Cherry Orchard Point

Quality Audit

Waterman Moylan

October 2023

Figure 3.1 – Examples of Where Parked Vehicles Could Impact Upon Crossing Safety

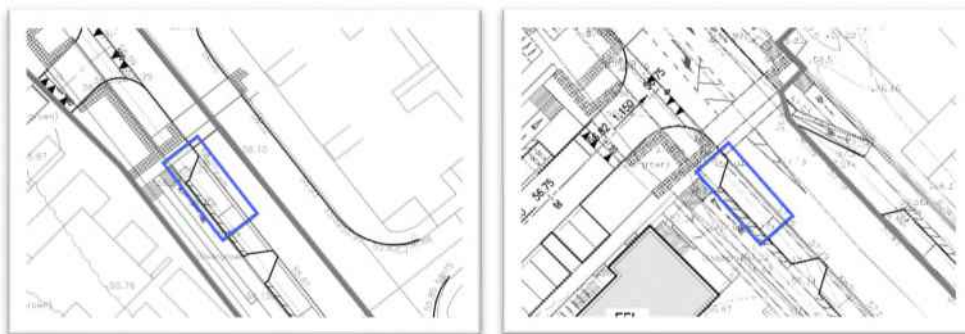
3.1 Problem: Parking Obscuring Forward Visibility to Crossing

Drg. | Location: P101, P102, P103 | Signal Controlled Pedestrian Crossings

The proximity of parking spaces to the adjacent pedestrian crossing could result in a parked car (or high-sided van / SUV) obscuring intervisibility between a pedestrian and an approaching vehicle. This is likely to increase the risk of conflict between vulnerable road users and vehicles.

Parking spaces on approach to all pedestrian crossings should be checked and adjusted as appropriate to maximise intervisibility between a pedestrian and an approaching vehicle.

Problem Reference (Section 3)	Designer Response Section			Audit Team Response Section
	Problem Accepted (yes / no)	Recommended Measure Accepted (yes / no)	Alternative Measures or Comments	Alternative Measures Accepted (yes / no)
3.1	Yes	Yes	<p>There are 2 No. proposed junctions on Park West Avenue with pedestrian crossings. The layout of these junctions have been reviewed and revised. The parking bays adjacent the crossing on the northern junction have been relocated as has the crossing itself.</p>  <p>The parking bays adjacent the crossing of the southern junction have also been relocated.</p>  <p>These relocations provide an extended buffer zone between pedestrian crossings and parking bays, further enhancing intervisibility</p>	Comment noted.

Figure 3.2 – Examples of Where Parking Could Impact Upon Safety at Priority Controlled Junctions

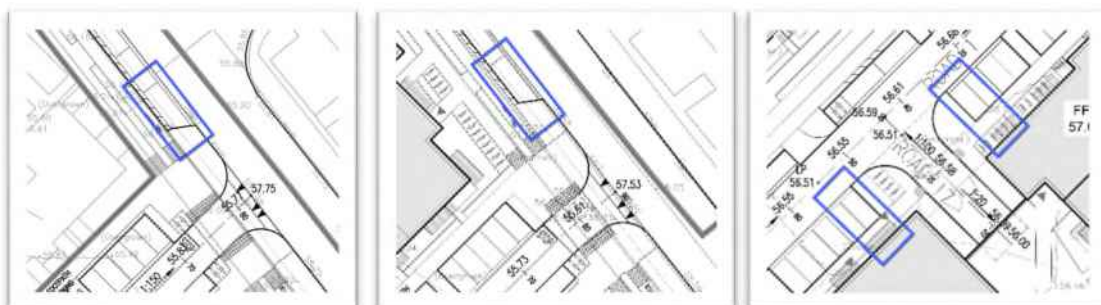
3.2 Problem: Parking Obscuring Junction Visibility

Drg. | Location: P101, P102, P103 | Priority Controlled Junctions

The proximity of parking spaces to an adjacent priority controlled junction could result in a parked car (or high-sided van / SUV) obscuring the junction’s envelope of visibility. This is likely to increase the risk of conflict between all road users at the junction.

Parking spaces in proximity to all priority controlled junctions should be checked and adjusted as appropriate to maximise each junction’s envelope of visibility.

3.2	Yes	Yes	<p>There are 3 No. priority junctions as part of the proposed development, 2 No. on Park West Avenue, and 1 No. entering/exiting the retail carpark.</p> <p>Sightline analysis has been undertaken on all these junctions.</p> <p>For the 2 No. priority controlled junctions on Park West Avenue, it is intended that the centreline roadmarkings will be formed by a solid white line, preventing overtaking. The sightline has been measured to the centreline of the road for traffic approaching the small arm of the junction from the left hand side. Visibility to vehicles approaching from the left is clearly facilitated.</p> <p>It is accepted that the sightlines do “clip” the parking bays on the right hand side to a certain extent however, the outline of a large family car (length 5.1m), indicates that the full sightline is provided. Visibility may be reduced in the event that high sided delivery vehicles occupy the space, and as such, temporary loading bays are facilitated elsewhere onsite to mitigate against this occurrence.</p> <p>For the junction entering/exiting the retail carpark, parking bays have been shifted to optimise visibility splays. It is noted that for a road design speed of 30KPH, full visibility of 23m is not provided, however, given the short length of straight road approaching this junction from the south (due to road curvature), and the north (from the junction) it is felt that a max achievable speed of 20KPH is more realistic and a required sightline of 14m for this design speed has been mostly achieved.</p> <p>Sightline analysis is shown in its full revision on Drawing Number: 22-010-P130.</p>	Comment noted.

Figure 3.3 – Cul de Sacs without Provision for Vehicles to Turn

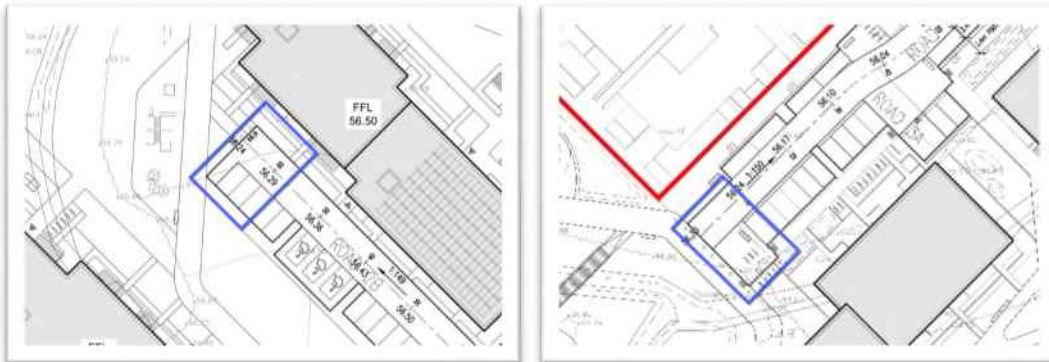
3.3 Problem: Provision for Vehicles to Turn Safely

Drg. | Location: P101 & P102 | Cul de Sacs on Road 2b & Road 3

The absence of a vehicle turning head at the end of the Cul de Sac's is likely to result in driver frustration, poor decision making and extended reversing manoeuvres which may lead to conflict with vulnerable road users.

Appropriate provisions should be made for vehicles to turn at the end of the Cul de Sacs.

3.3	Yes	Yes	Provisions have been made to incorporate turning heads to the layout on cul-de-sacs. Please refer to Drawing Numbers: 22-010-P101 & P102.	Comment noted.

Figure 3.5 – Locations Where Cycle Tracks Appears to Displace Existing Footpath Facilities

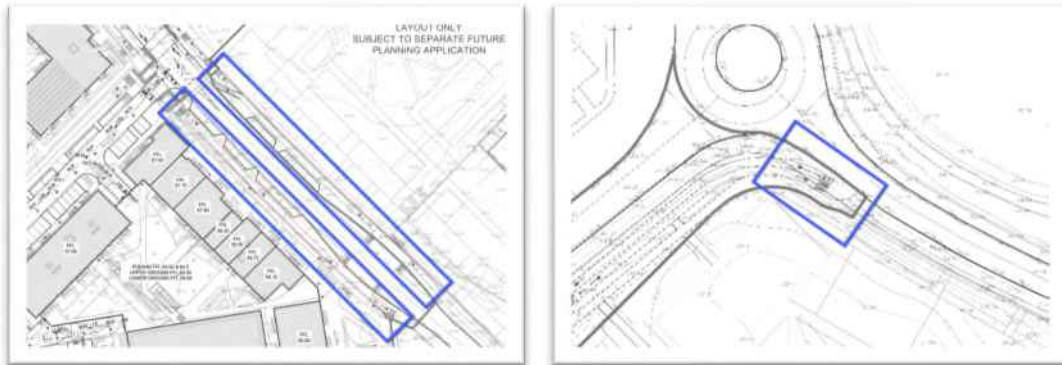
3.5 Problem: Space for Continuity of Existing Footpaths

Drg. | Location: 103 | Park West Avenue & Cedar Brook Way

The provision of cycle tracks at these location does not appear to retain any space for the existing footpath and therefore pedestrian progression. This could lead to a pedestrian walking in the cycle lane or the traffic lane, increasing their risk of conflict and injury.

Appropriate footpath facilities should be provided at the locations described.

3.5	Yes	Yes	<p>The proposed pedestrian and cycling connection to the existing infrastructure has been revised.</p> <p>The proposed infrastructure now ties in more clearly to the existing. Where cycle lanes end, tactile paving and signage will be provided advising of this and drop kerbing will be installed facilitating cyclist connectivity to rejoin the road surface and cycle lanes.</p> <p>Please refer to Drawing Number: 22-010-P010.</p>	Comment noted.

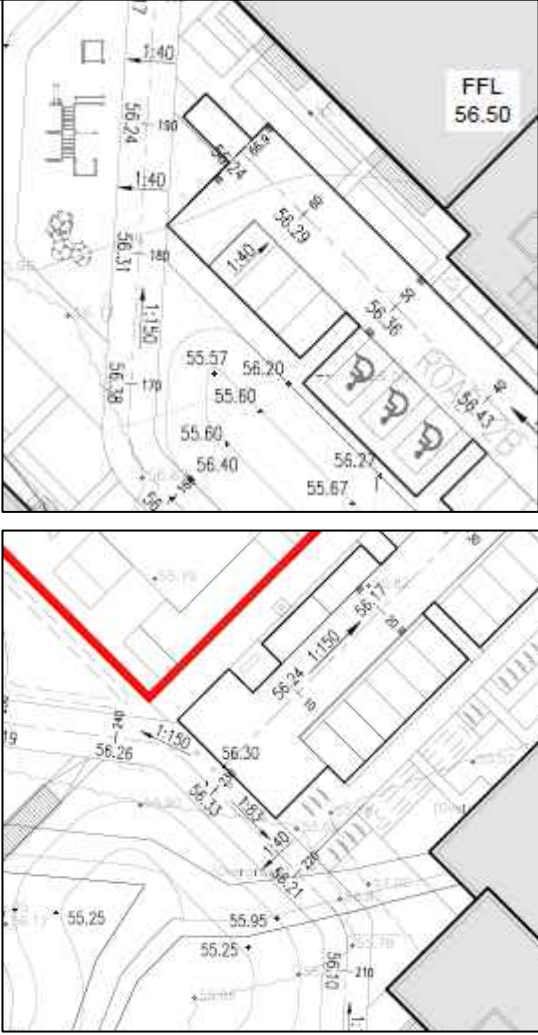
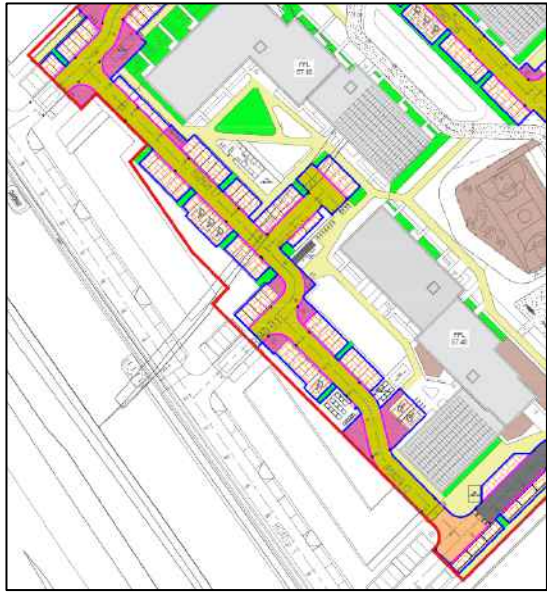
3.4	Partially	Yes	<p>This area is to be a private gated carpark serving the parking bays for the adjacent apartment blocks only. It is not intended that this location provide unrestricted and continuous freedom of movement to the general public. This is provided through the central green corridor. It is however noted that pedestrian and cyclist connectivity to residents in this location is already facilitated via the homezone. This homezone is announced to motorists via a ramp up and change in colour to the proposed road surfacing with a buff-coloured macadam. Signage shall also be introduced to notify</p>	Comment noted.

Problem Reference (Section 3)	Designer Response Section			Audit Team Response Section
	Problem Accepted (yes / no)	Recommended Measure Accepted (yes / no)	Alternative Measures or Comments	Alternative Measures Accepted (yes / no)
			<p>motorists of the change in priority. Refuge areas are provided to enhance pedestrian comfort and safety. Where a footpath connects to a refuge area for pedestrian access to the homezone road surface, tactiles are provided announcing the change in surface to the pedestrian as well as drop kerbing facilitating the movement of wheelchairs and prams etc. Please refer to Drawing Number: P22-010-P010 which clarifies the intended road surface type at this location.</p>
